Anthropomorphic Test Devices; Hybrid III Test Dummy, ES-2re Side Impact Crash Test Dummy

ACTION: Final rule.

SUMMARY: This document corrects or makes minor changes to some of the drawings incorporated by reference into NHTSA regulations by a final rule published on June 16, 2008, concerning a 50th percentile adult male side crash test dummy called the “ES-2re” test dummy. The corrections and adjustments to the drawings respond to requests from test dummy manufacturers First Technology Safety Systems (FTSS) and Denton ATD (Denton). This final rule also corrects dimensional errors in a figure which depicts the pendulum used in the neck qualification tests of several of the crash test dummies, including the Hybrid III and ES-2re test dummies.

**Figure 1: Corrections to pendulum dimensions
in Figure 22 of Section 572.33(c)(3)**

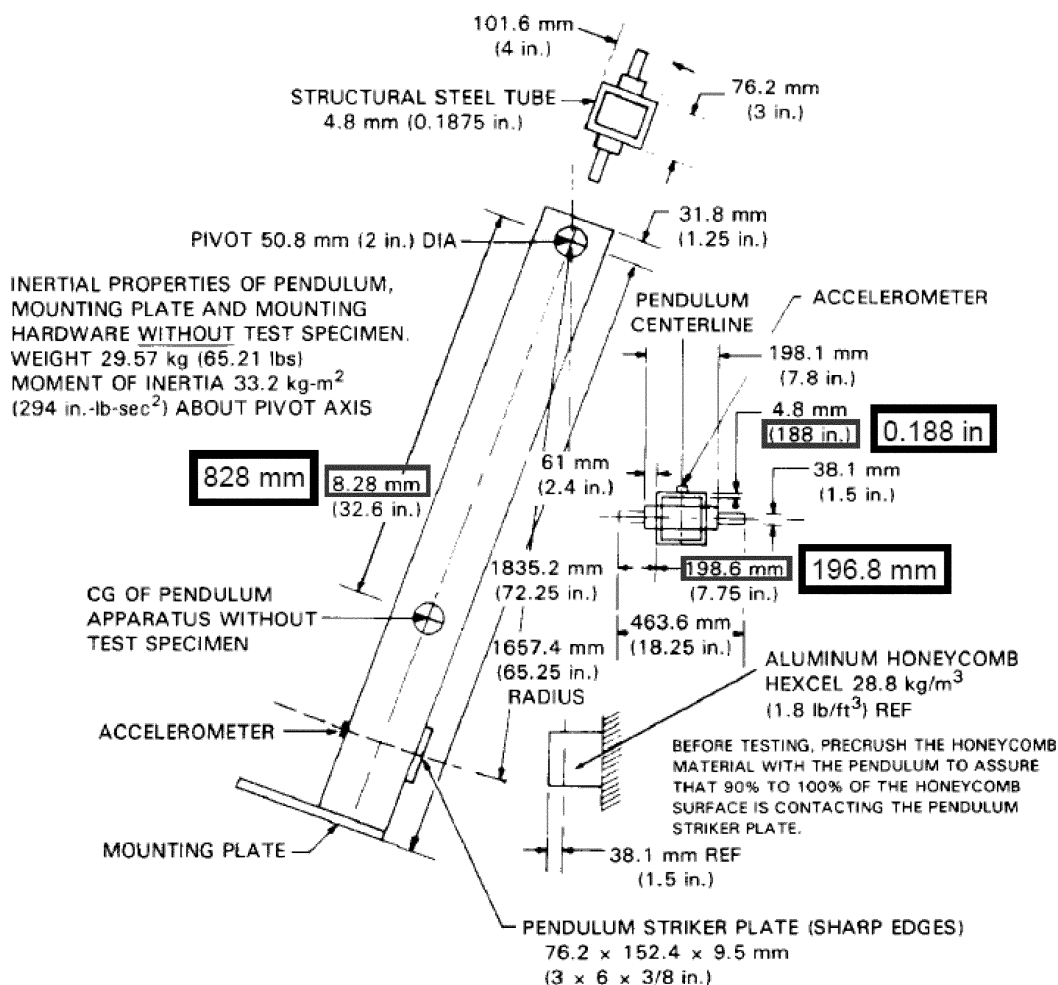
This final rule corrects several dimensional values in Figure 22, “Pendulum Specifications,” of 49 CFR part 572. This pendulum is used in neck qualification tests for the ES–2re as well as other adult crash test dummies, including the Hybrid III 50th percentile male and 5th percentile female frontal crash test dummies, the SID–IIIsD 5th percentile female side impact dummy, and the SID and SID/HIII side impact crash test dummies. The dimensional corrections are listed below and shown in Figure 1 of this preamble, below:

- The 8.28 millimeter (mm) (32.6 inch (in)) dimension is changed to 828 mm (32.6 in);
- The 4.8 mm (188 in) dimension is changed to 4.8 mm (0.188 in);
- The 198.6 mm (7.75 in) dimension is changed to 196.8 mm (7.75 in).

FIGURE 22
PENDULUM SPECIFICATIONS

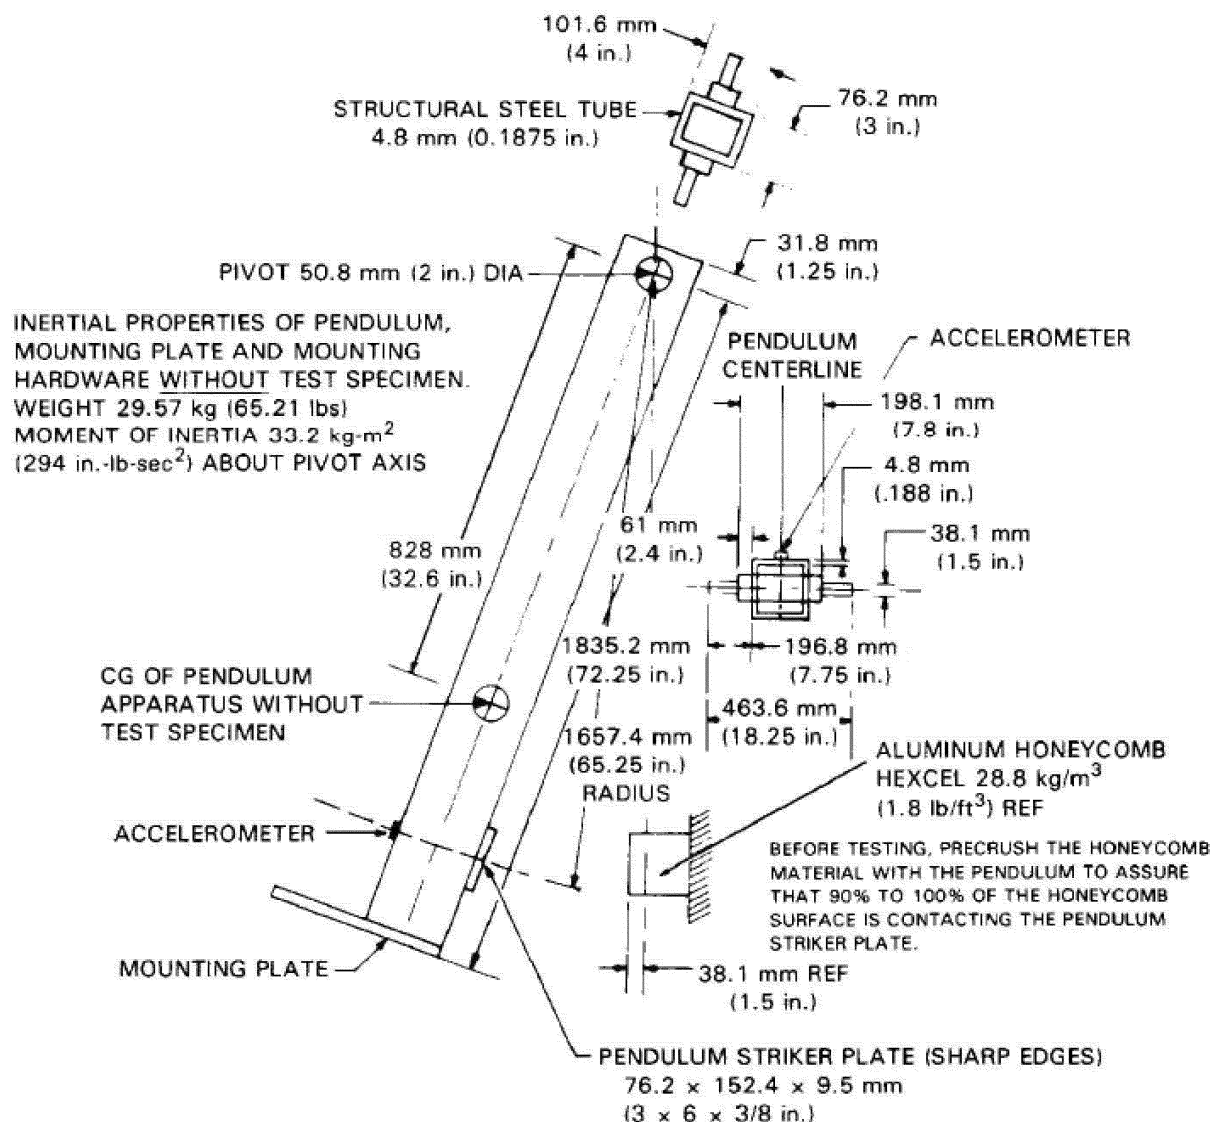
■ 2. In § 572.33(c)(3), Figure 22 is revised to read as follows:
